Dresden Nuclear Power Station, Units 2 and 3
Facility Operating License Nos. DPR-19, and DPR-25
NRC Docket Nos. 50-237 and 50-249

Subject: Response to Request for Additional Information Regarding Unresolved Safety Issue (USI) A-46

ATTACHMENT A
Response to Request for Additional Information for Dresden Nuclear Power Station
Unresolved Safety Issue (USI) A-46

Figure 1
Reactor Building - Elevation 545

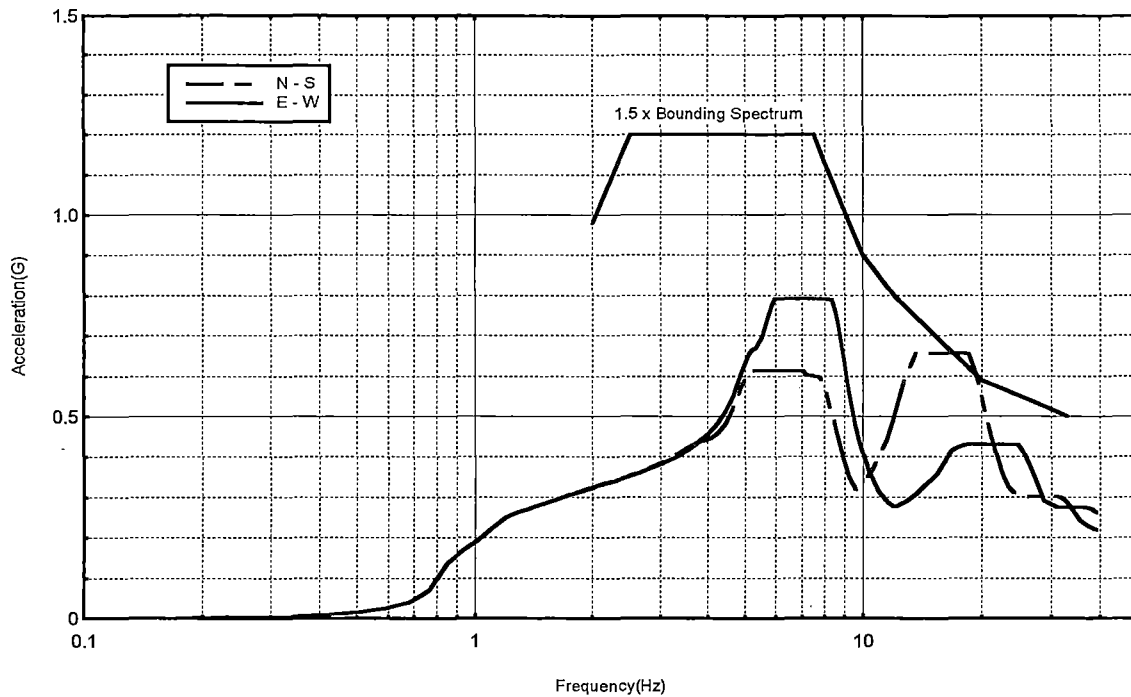
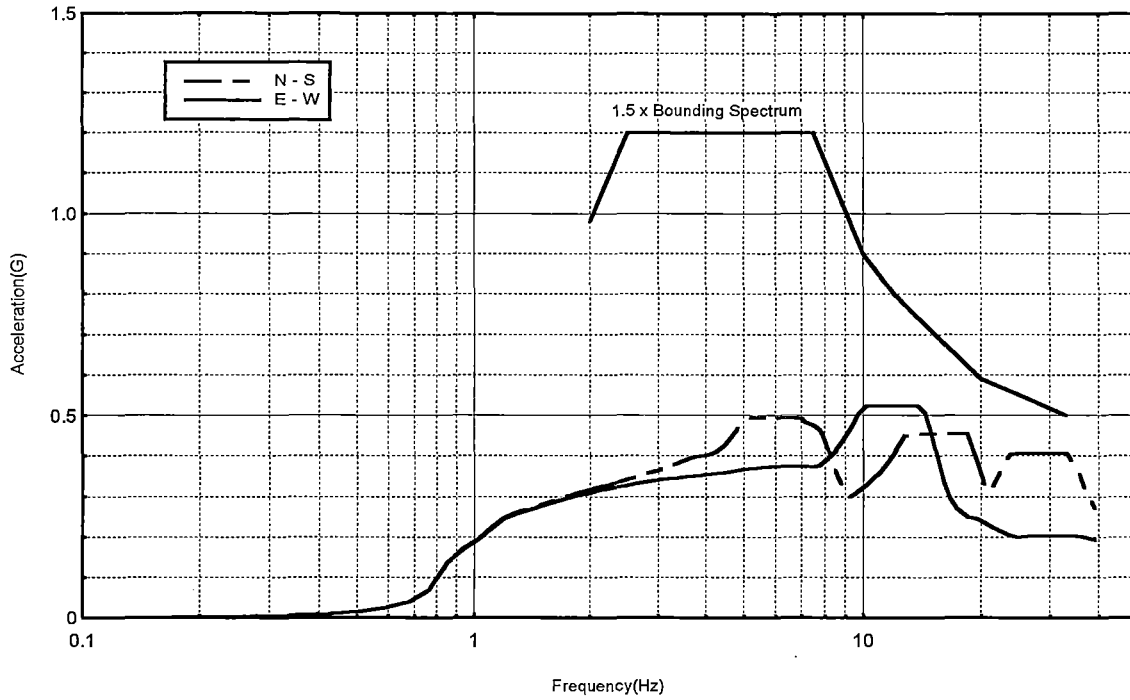
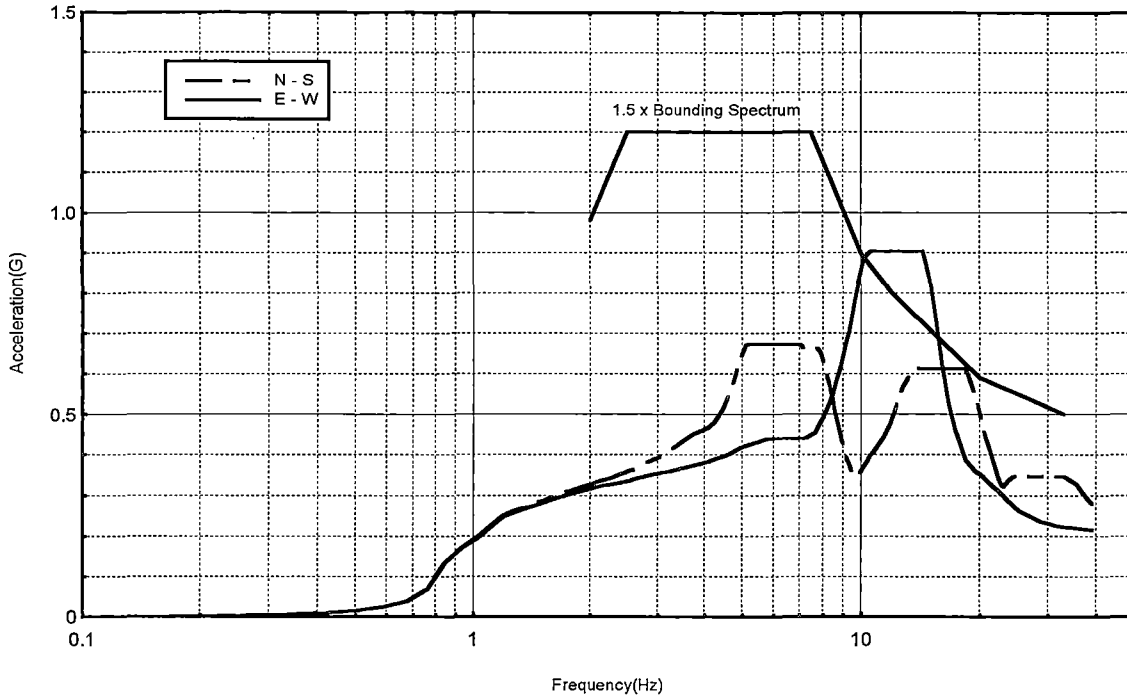
In response to the staff's question on the appropriate use of Method A of Table 4.1 of generic implementation procedure number two (GIP-2), you make reference to the Seismic Qualification Utility Group's (SQUG) letter of January 1998 (Reference 3). The staff is aware of the bases provided in the reference. More recently, SQUG has acknowledged in its letter of August 18, 1998, and the staff has agreed to in its letter to SQUG of September 21, 1998: "Any plant-specific implementation concerns should be addressed in the plant-specific evaluations." The restriction on the use of Method A comes from the discussion of "Advantage and Limitations" in Section 4.2.3 of GIP-2, where it is noted that "Seismic Capability Engineers should be alert for unusual, plant specific situations which could cause the amplification factor to be greater than that of typical nuclear plant structures." A review of some of the in-structure response spectra (IRS) provided in Appendix B (Reference 1) shows that at several elevations, the IRS in the Reactor Building and Turbine Building have double peaks (broadened); (1) between 4 and 8 Hz, and (2) between 12 and 20 Hz. This indicates a plant-specific situation. The staff's concern is about the seismic adequacy of equipment including their supports and anchorages (such as electrical equipment, valves, and electrical relays or contacts) located within 40 feet above the effective grade of 517 feet. In light of this discussion (1) provide justification for the use of Method A, (2) as an example, provide your justification for seismic adequacy of safe shutdown equipment list (SSEL) equipment installed on Elevation 549 feet of the turbine Building.

Specifically, we used Method A to estimate seismic demand for certain equipment within 40 feet of effective grade at the Dresden Nuclear Power Station. The NRC has questioned our use of Method A on the basis that Method A may only be used for typical nuclear plant structures citing that Dresden has "double peak spectra" which may indicate a possible plant-specific situation that the Seismic Capability Engineers should have been alert to. As a result, the staff is concerned with the seismic adequacy of equipment located within 40 feet above the effective grade of 517 feet and specifically the equipment located on the Turbine Building elevation 549 feet.

Figures 1 – 3 show the refined ISRS broadened by $\pm 15\%$ compared to the GIP reference spectrum (1.5 x bounding spectrum) for the Reactor and Turbine building elevations within 40 of grade for which Method A has been utilized. All of our refined ISRS are enveloped by the GIP reference spectrum with a single minor exception of the East-West ISRS of the Turbine building at elevation 549 feet. (Note that the marginal exceedance for the North-South direction of the Reactor building is acceptable by Section 4.2 of the GIP). For elevation 549 feet of the Turbine building, the broadened refined ISRS exceeds the reference spectrum between about 10-15 Hz. In Section 4.2 of the GIP, it is stated that unbroadened response

- New, more refined ISRS are developed for Dresden Nuclear Power Station for A-46 outlier resolution. The development of these new spectra is described above and the broadened spectral plots are shown in Figures 1-3. For elevations where Method A was utilized, the new spectra are enveloped by the SQUG reference spectrum with the single exception of a narrow band exceedance of about 15% for the East-West direction of elevation 549 feet of the Turbine building as shown in Figure 4. These new refined spectra still contain conservative bias that artificially increases amplifications over those that would be expected in an actual earthquake. Further, the expected differences between calculated and actual building responses do not represent a significant safety issue for resolution of USI A-46. Our bases for this are given in Attachment C.
